Project Title:  
PROPOSED ALTERATIONS  
& ADDITIONS TO  
EXISTING DWELLING  
FOR  
MR & MRS CS SMITH  
AT  
6 REGENT PLACE  
DURBAN NORTH

Drawing Title:  
REFERENCE NOTES;  
SITE & FLOOR PLANS

Date: SEPT 1994 Drawn: JAS/CVL Drawing Number: 9408/WD1

AS BUILT

SITE & FLOOR PLAN  
1:100

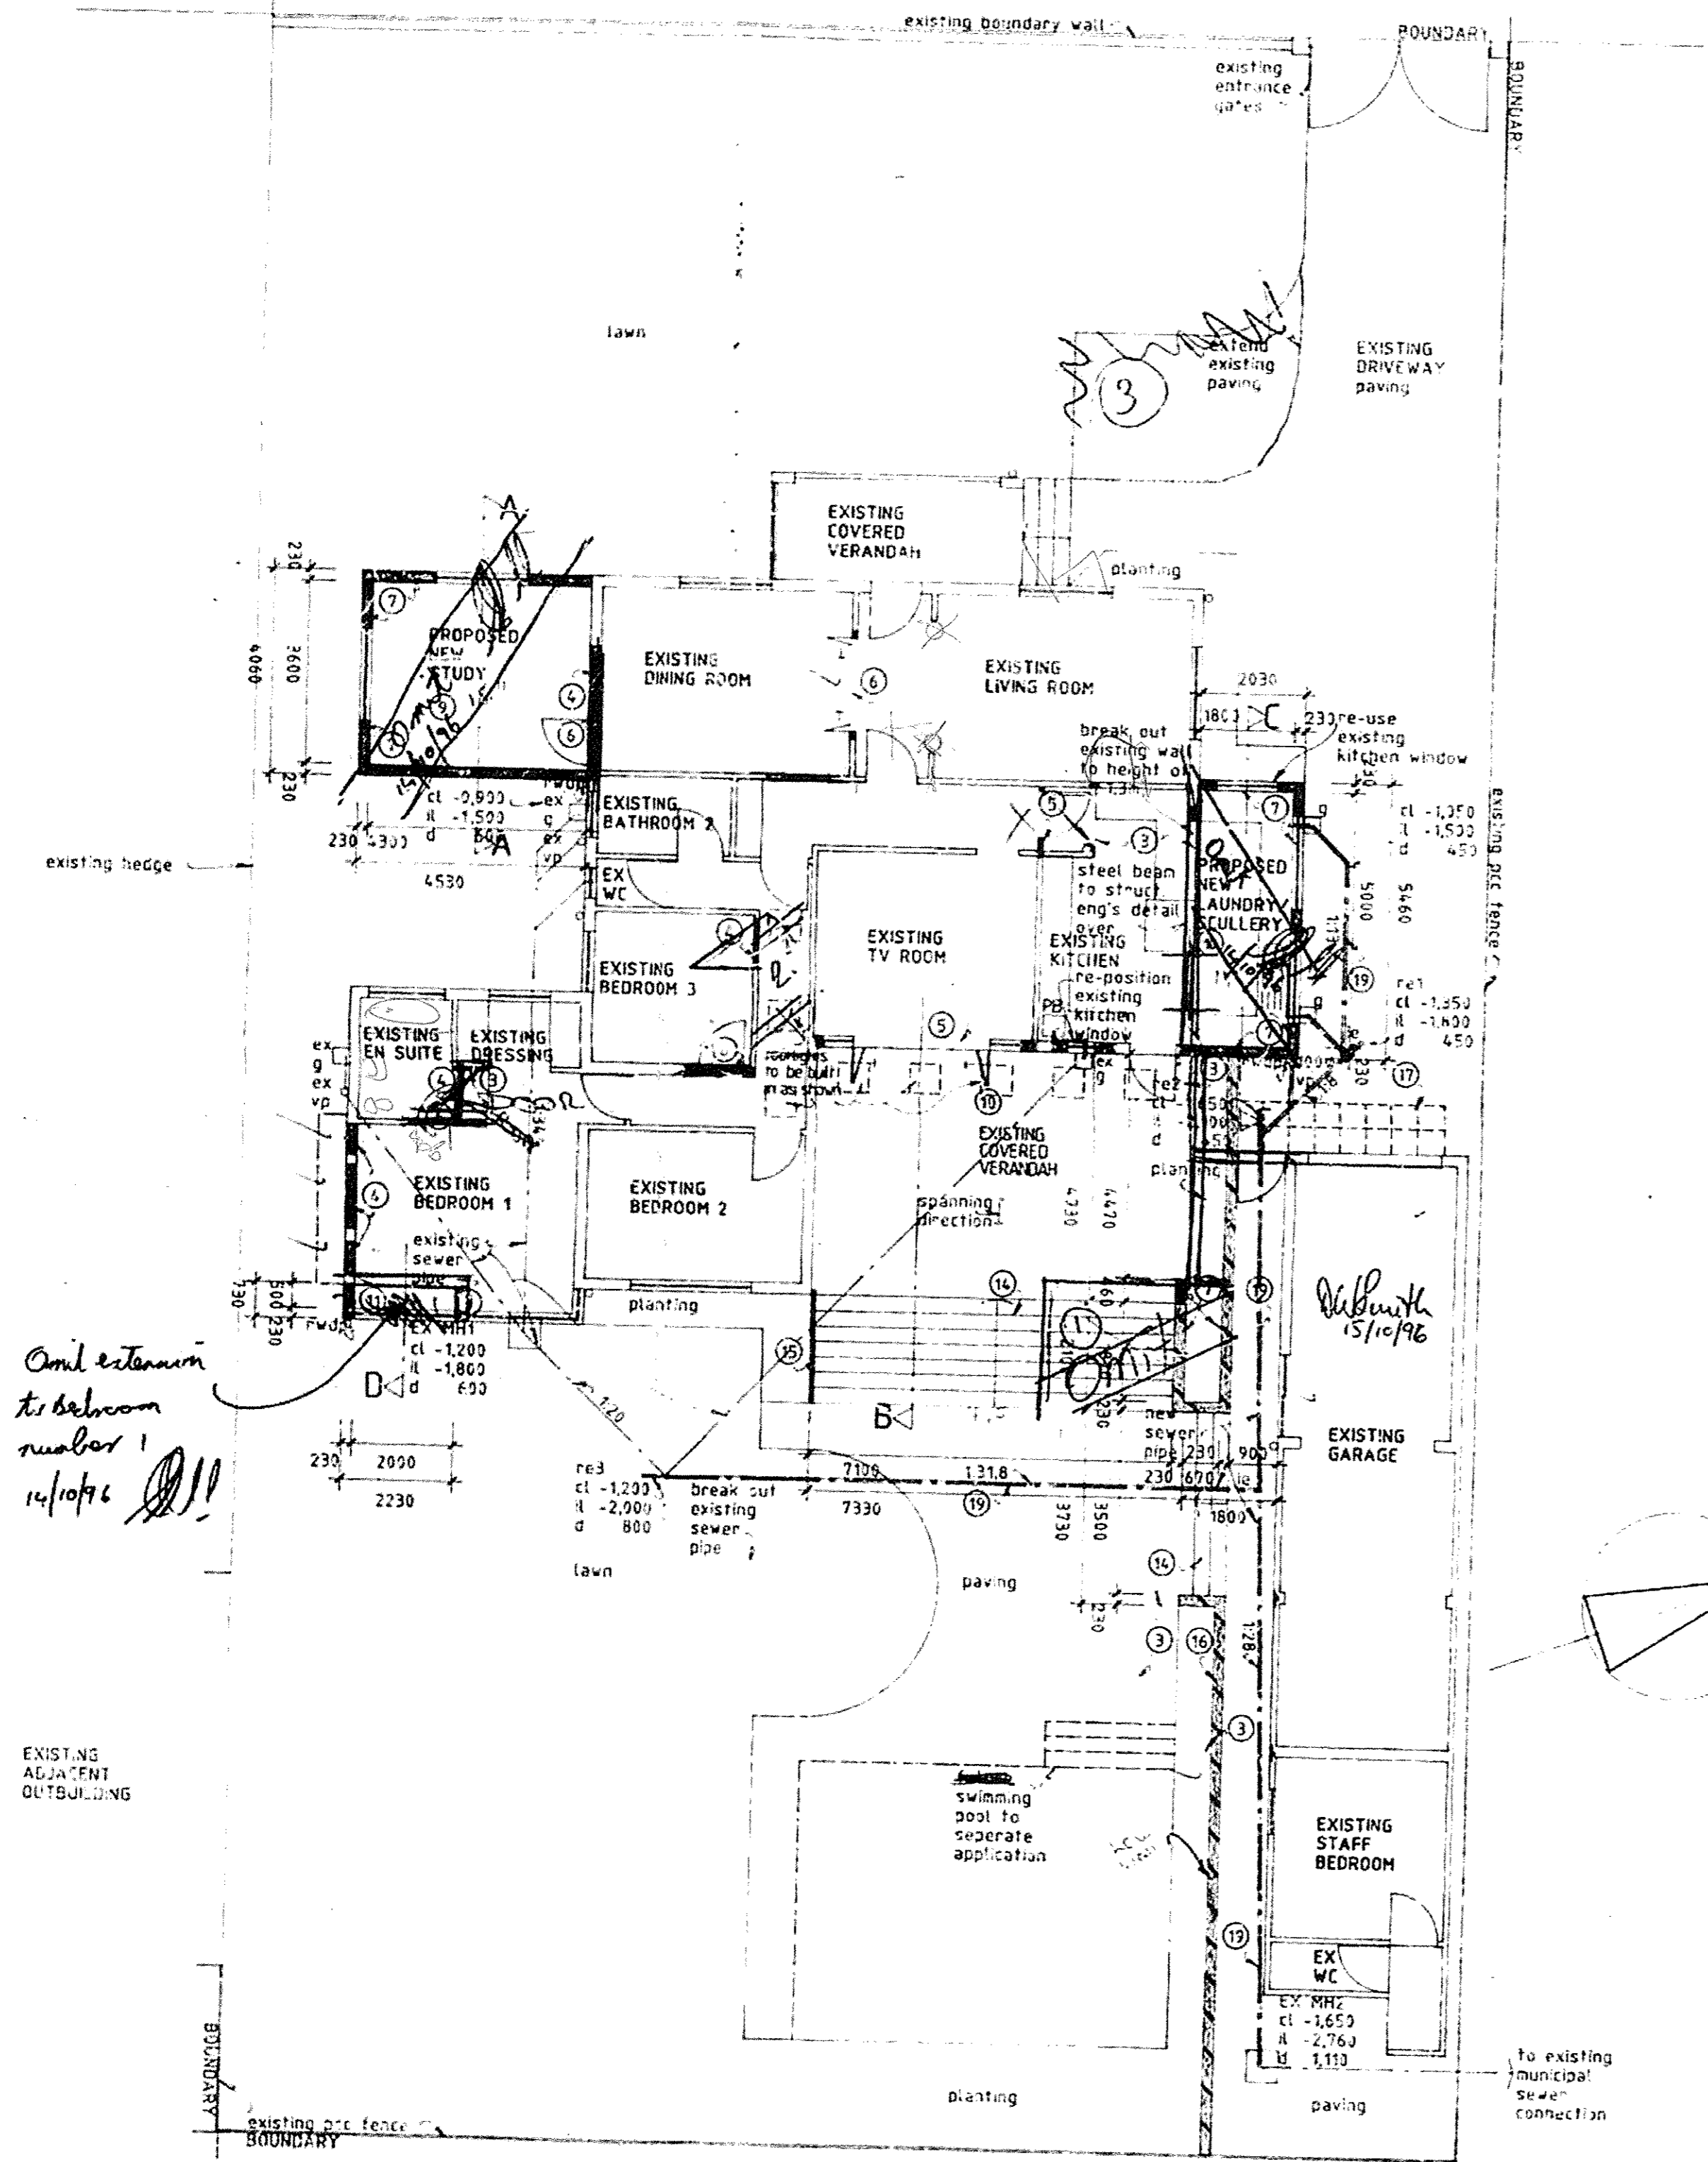
- 1) Steps at Covered Verandah Has Been changed
- 2) Sky-Lights omitted from Plan
- 3) Paving Not Extended
- 4) Bathroom Door to remain as existing
- 5) Study, Laundry, Bed Room & Staff Bed omitted from Plan
- 6) East Elevation changed.

omit extension to bedroom number 1 14/10/16
